# ACCESS AUDIT REPORT

# VIGYAN BHAWAN

23<sup>rd</sup> September 2009

**National Centre for Accessible Environments**

### PATHWAYS

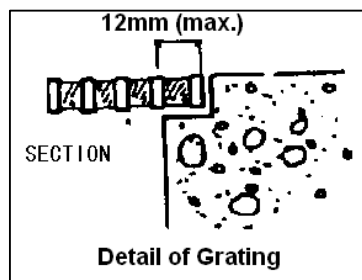
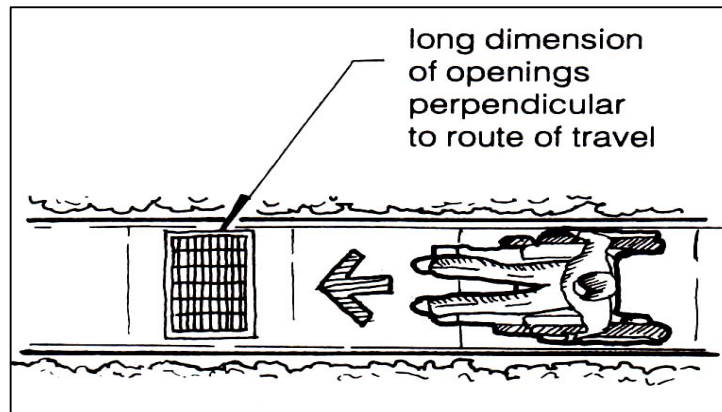
**Gratings** trapped the front wheels of the wheelchair and white cane of persons with vision impairment. Other barriers such as uneven surface and gaps pose a trip hazard for persons with vision impairment and thereby restrict safe movement.

- ✚ Periodic general maintenance of pathways to be ensured.
- ✚ Gratings should not be wider than 12mm and should be placed outside the line of travel. However where un-avoidable, strip of net/mesh to be securely fixed on to the existing gratings. Same can be removed while cleaning /maintaining the drainage.

- ✚ Gratings may also be placed perpendicular to the movement of travel as illustrated.

## WAY FINDING SIGNAGES

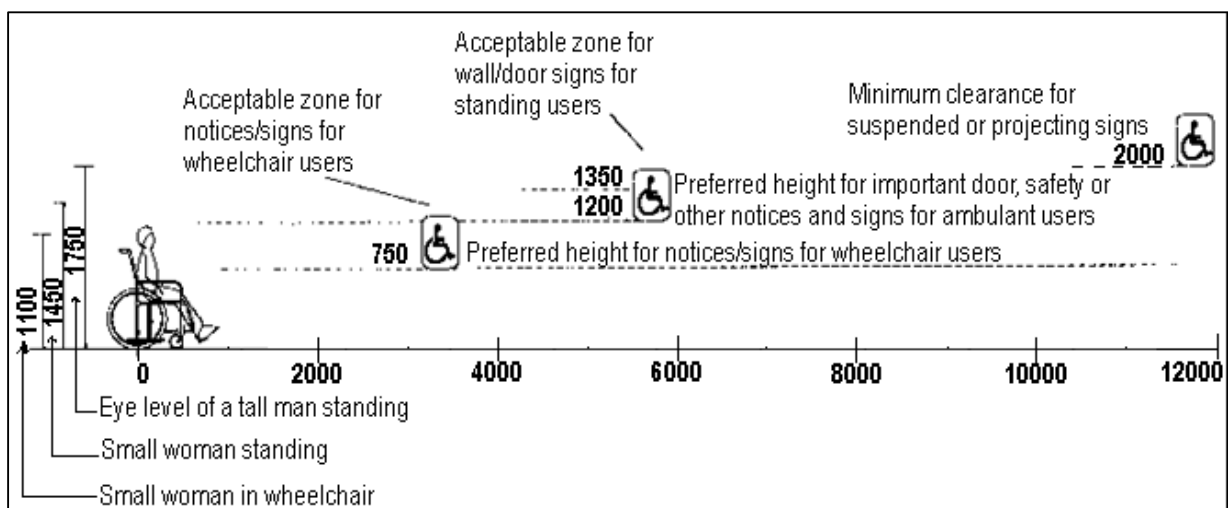
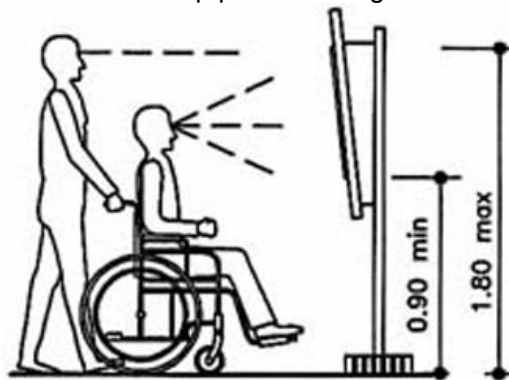
Directional signs have been provided at the turning from main road. However, there are no route map and/or directional signboard for Gate nos. etc. upon entering.

- Directional signs are proposed for the benefit of visitors specially those coming for the first time.

## GENERAL PARKING

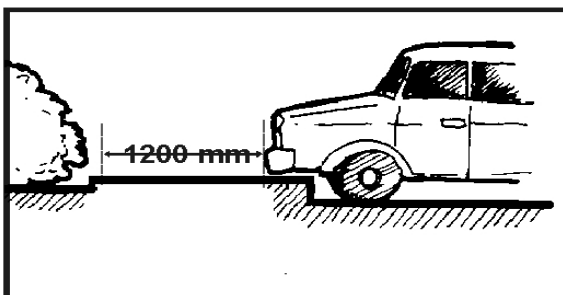
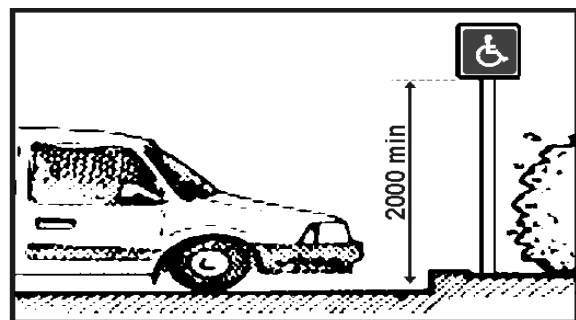
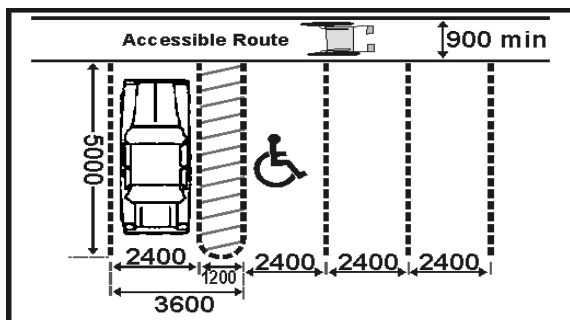
Demarcated parking lots have been provided inside Vigyan Bhawan. However, haphazard vehicle parking on the pathways obstructs right of way and safe movement of everyone including persons with disabilities.

- Parking area to be clearly specified with directional signage.
- Parking to be prohibited on pathways and enforceable to the demarcated areas.

## BUILDING ENTRANCES & SIGNAGE

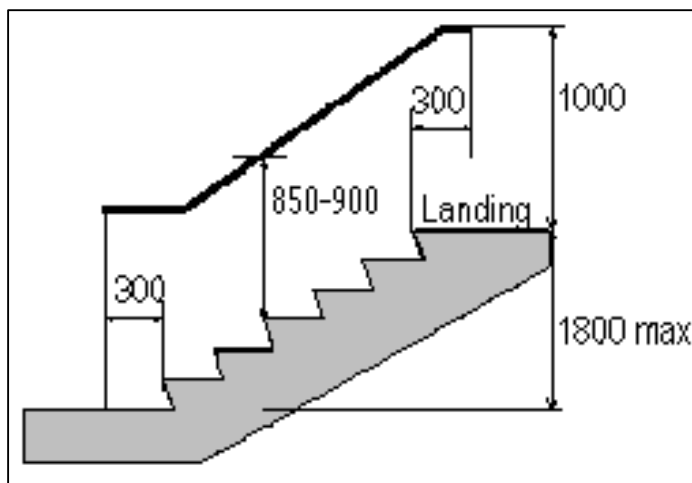
Signage for gate entrances has either not been provided or is not at eye level.

- ✚ Information signs are proposed at all entrances.
- ✚ Refer recommendations for positioning of information signs on page no. 5 & 6.
- ✚ Consistency in placement, colour and font size of signage to be maintained.

## EAST GATE

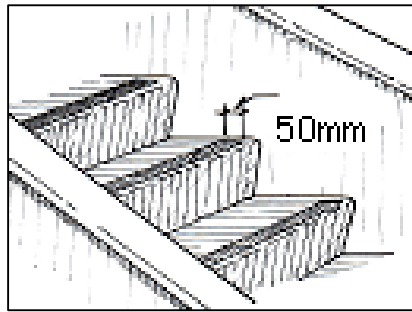
This entrance is demarcated for general public entry. Steps do not have handrail making it difficult for persons using mobility aids such as sticks and crutches, who prefer to use steps.

- ✚ Handrails on both the sides of the steps to be provided, at two levels, for balance and support for persons with reduced mobility.
- ✚ Handrails to extend by at least 300mm beyond the head and foot of the flight in the line of travel and grouted in the ground (refer illustration).
- ✚ Refer Annexure II for steps and Annexure III for handrail height and diameter standards.

- ✚ Step edges (50mm minimum) should have bright contrasting colors, which helps persons with low vision to identify height and depth of each step (as illustrated). Alternatively the risers can also be painted in contrast colours.

- ✚ Warning strip (Annexure IV) to be provided 300mm before and after the steps, so that a person with vision impairment does not accidentally trip.
- ✚ Security personnel to be sensitized to inform persons using mobility aids such as wheelchair to use the ramp at West Gate or South Plaza Gate.
- ✚ Signage for ramp, with directional arrow for West Gate or South Plaza Gate to be provided.

## WEST GATE

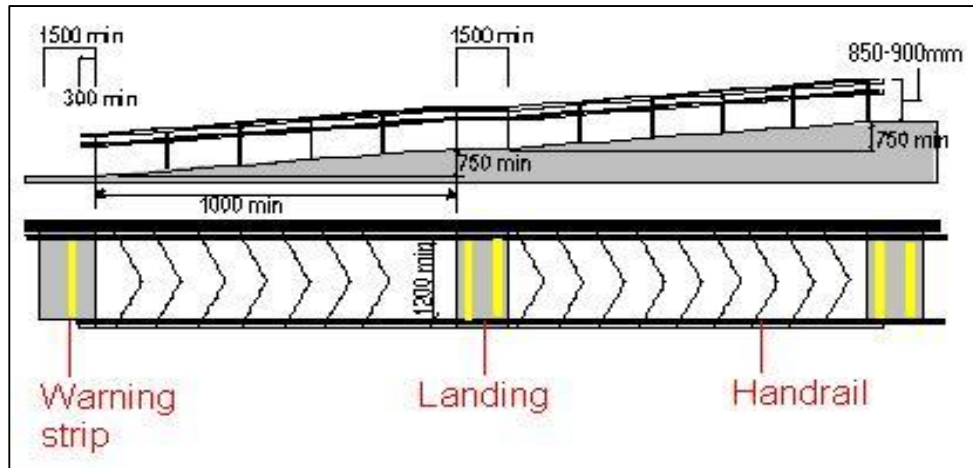
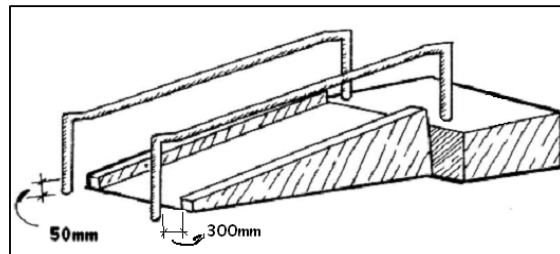
The plinth height is 600mm. An inward cut ramp which maintains the symmetry of the plinth is proposed.

- ✚ Ramp with 1:12 gradient minimum and handrail on both sides to be provided (as illustrated above).
- ✚ Warning strip (Annexure IV) to be provided 300mm before and after the ramp, so that a person with vision impairment does not accidentally trip.

- ✚ Handrails to extend by at least 300mm beyond the head and foot of the ramp in the line of travel and grouted in the ground (refer illustration).
- ✚ Handrails to be painted in bright colours preferably yellow/red for easy identification by persons with low vision.
- ✚ Signage for ramp to be provided.
- ✚ Refer Annexure I and III for ramp and handrail standards.
- ✚ Ramp surface to be anti-slip/matt finish preferably flamed granite.

### GREEN ROOM (ENTRY NEAR WEST GATE)

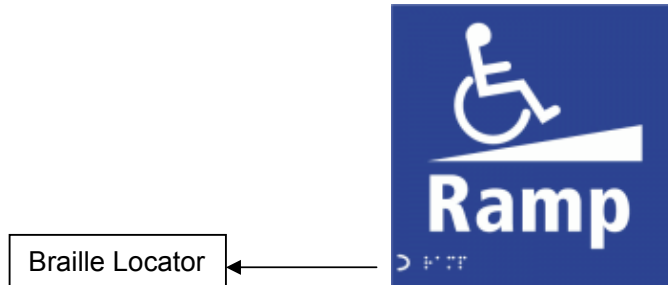
The ramp is fairly accessible. However, handrails have not been provided on the ramp. Guard rail have also not been provided on landing.

Existing ramp without handrails & guard rail

- ✚ Handrails on both the sides of the ramp to be provided. Refer Annexure III for handrail standards.
- ✚ For preserving the aesthetics and blending with surroundings, a guard rail made of Agra stone (*jali* as shown) is proposed for landing of the ramp.
- ✚ Warning strip (Annexure IV) to be provided 300mm before and after the ramp edges, so that a person with vision impairment does not accidentally trip.
- ✚ An overhead shelter is also proposed over the ramps, for protection during adverse weather conditions.
- ✚ Signage for ramp to be provided. The signage given below is also in Braille.

### ENTRANCE (SOUTH PLAZA)

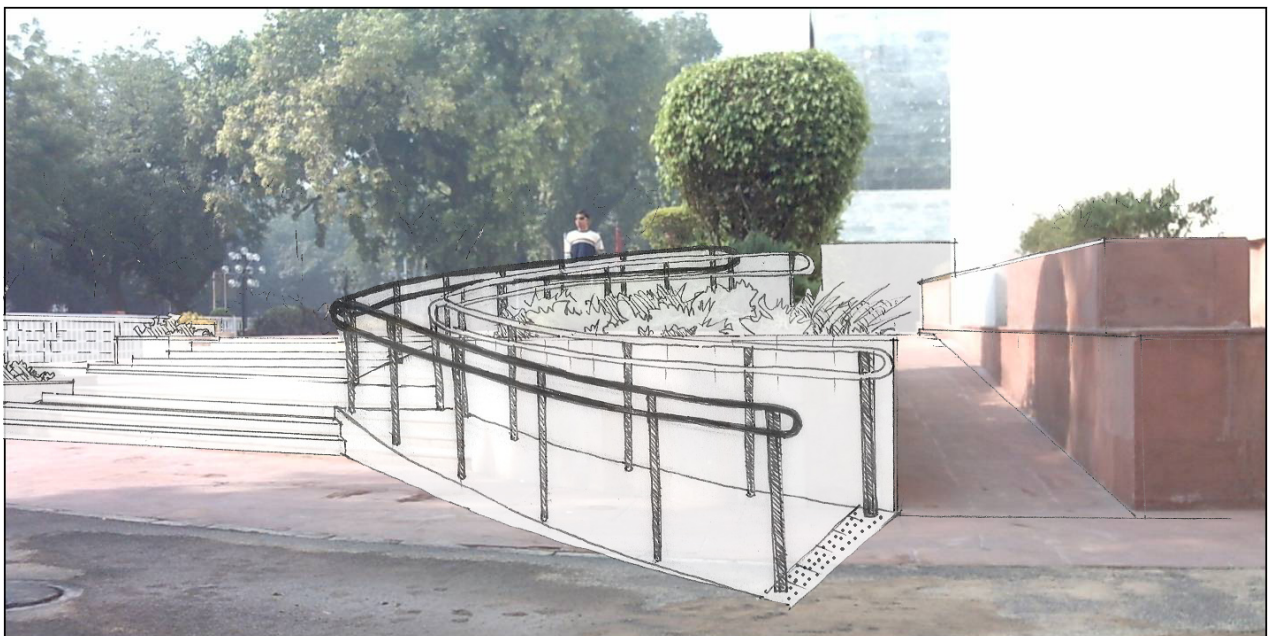
There is a good combination of steps and ramp. However, handrails have not been provided for steps and ramp and the ramp gradient is steep (approx.1:8).

Signage for ramp has been provided. However it is obscured by tree branches.

- ✚ Regular pruning of overgrowth to be undertaken to provide optimum signage visibility.

- ✚ Circular ramp to be provided (as illustrated) so as to provide 1:12 minimum gradient.
- ✚ Handrail on both sides of ramp and steps to be provided (refer Annexure III).
- ✚ Handrails to extend by at least 300mm beyond the head and foot of the ramp and steps in the line of travel and grouted in the ground.
- ✚ Handrails to be painted in bright colours preferably yellow/red for easy identification by persons with low vision.

- ✚ Warning strip (Annexure IV) to be provided 300mm before and after the ramp and step edges, so that a person with vision impairment does not accidentally trip.
- ✚ Step edges (50mm minimum) should have bright contrasting colors, which helps persons with low vision to identify height and depth of each step (as illustrated on page 10).

## RECEPTION (INFORMATION & REGISTRATION)

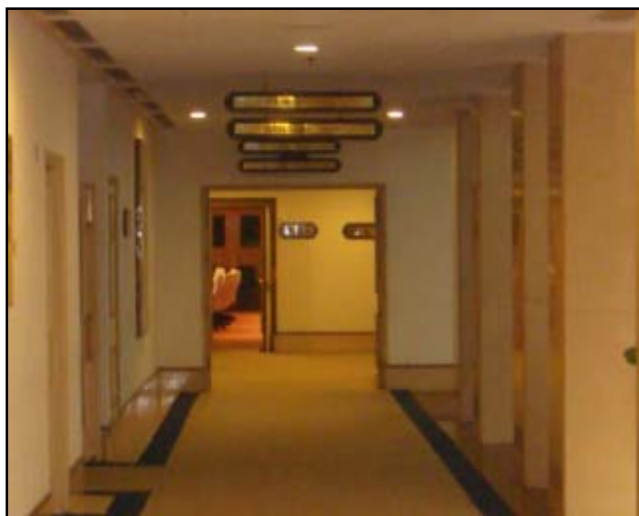
The existing counter height is 1000mm. Signages are placed quite high.

- ✚ A portion of the counter to be lowered down to 800mm (as illustrated).

- ✚ Staff manning the counters should know sign language.
- ✚ Signage in big fonts to be placed at eye level.

- ✚ Signage with Braille markings (as illustrated) to be displayed to assist persons with diverse disabilities.

## DINING HALL

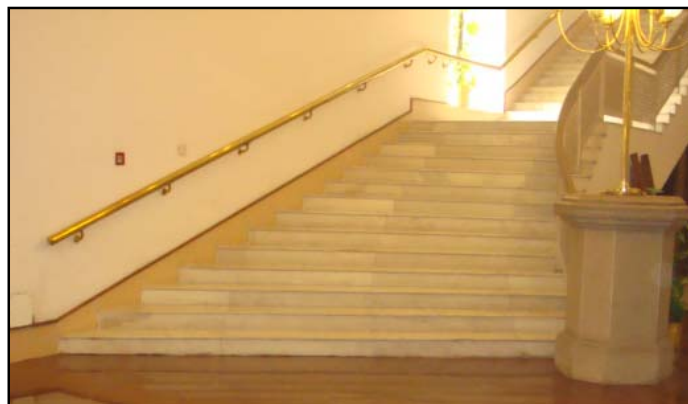
Hall and serving table counter height is fairly accessible.  
Flooring is slippery.

- ✚ Flooring to be anti skid/matt finish which benefits everyone.

## STAIRS

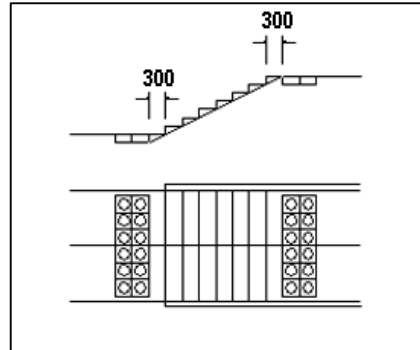
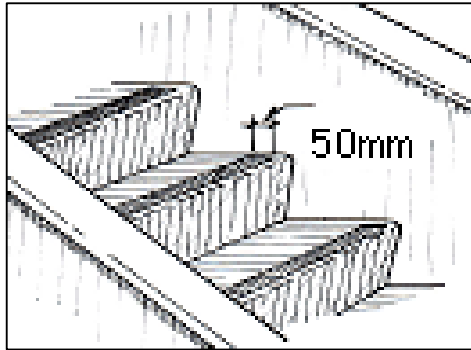
Differentiation of height and depth of steps is not possible by persons with low vision.

- ✚ Step edges (50mm minimum) should have bright contrasting colors, which helps persons with low vision to identify height and depth of each step.
- ✚ Warning strip (Annexure IV) to be provided 300mm before and after the step edges, so that a person with vision impairment does not trip accidentally.

## ACCESS TO DAIS

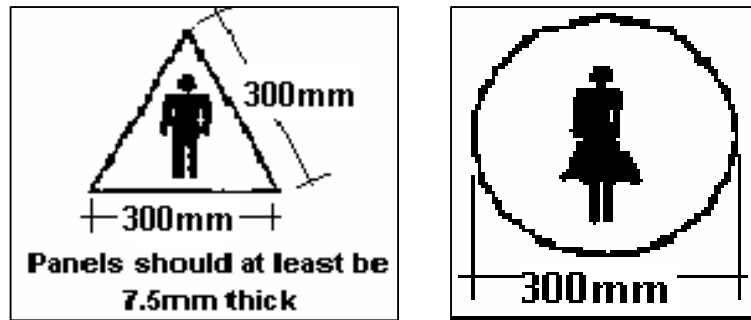
The dais floor is 1050mm above the hall floor level. Several options such as provision of ramp and platform lift were discussed with the accompanying engineering staff.

- A permanent ramp (wooden structure) width 900mm to be provided over the steps.
- The ramp shall follow a curve, thereby avoiding relocation/shifting the lectern (as illustrated).
- Similar carpeting to be provided on the ramp surface and sides.
- Edge protection (colored red in illustration) on both sides to be provided, in lieu of handrails.

- A hydraulic/manual platform lift with toughened glass edges can be provided, that blends with the aesthetics of the hall. Matching carpet should be laid down on the flooring of the lift.
